**PSEG Nuclear LLC**

LR-N13-0302  
January 8, 2014

Salem Generating Station, Units 1 and 2  
Renewed Facility Operating License Nos. DPR-70 and DPR-75  
NRC Docket Nos. 50-272 and 50-311

**Subject: Response to Request for Additional Information (RAI 31 and RAI 32)  
– Relief Request SC-I4R-133, Alternative Repair for Service Water  
System Piping**

Figure 1 - Potential Areas of Degradation

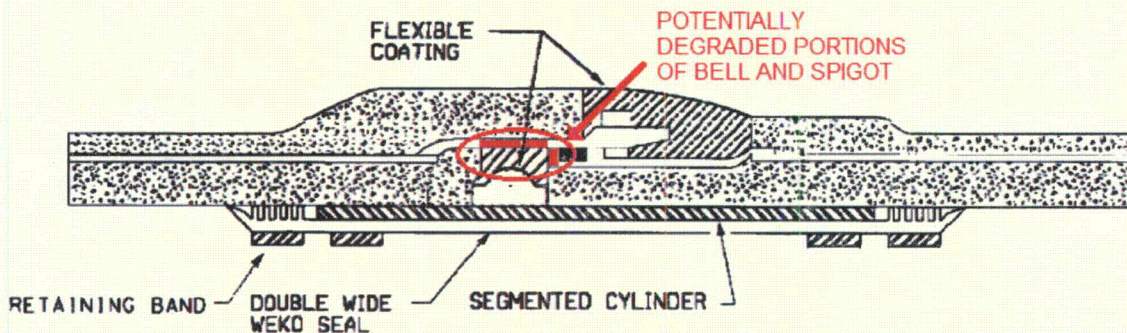
*(c) Provide a sketch or drawing showing the potential location(s) of such defect area on the bell-spigot joint.*

- During construction of the service water system piping, the exterior of each bell and spigot joint was sealed with a pre-formed flexible sealant (e.g., Ram-Neck), which prevents ground water intrusion into the bell and spigot joint, even if the steel bell ring is degraded (see Figure 1). PSEG has excavated several buried service water pipe joints and has not identified any instances of degradation of the exterior joint sealant that would result in exposure of the joint to groundwater.

- PSEG cleans and coats the degraded bell ring as part of the WEKO seal repair. If there were any service water leakage past the WEKO seal, the coating would prevent further degradation of the bell ring from exposure to service water and provide another barrier to leakage (See Figure 1).

- Hoop Strength - The existing bell and spigot joint provides hoop strength to resist circumferential loads (e.g., internal pressure of the pipe). The WEKO seal repair includes a stainless steel plate (shown as "segmented cylinder" in Figure 1) that fits over the joint and is secured to the mortar interior of the piping by retaining bands. The stainless steel plate bears circumferential loads and removes the existing bell and spigot joint from the load path. Accordingly, the WEKO seal repair fulfills the hoop strength function of the bell and spigot joint.

c. Figure 1 highlights the portions of the bell and the portions of the spigot that could be degraded by exposure to service water. Figure 1 shows how these portions would be protected from future exposure to service water by the WEKO seal and a flexible coating. Additionally, the flexible coating on the outside of the joint provides protection from groundwater intrusion. Note that the portion of the spigot that is exposed to service water is not part of the load path for axial loading and is therefore not relevant for structural evaluations.
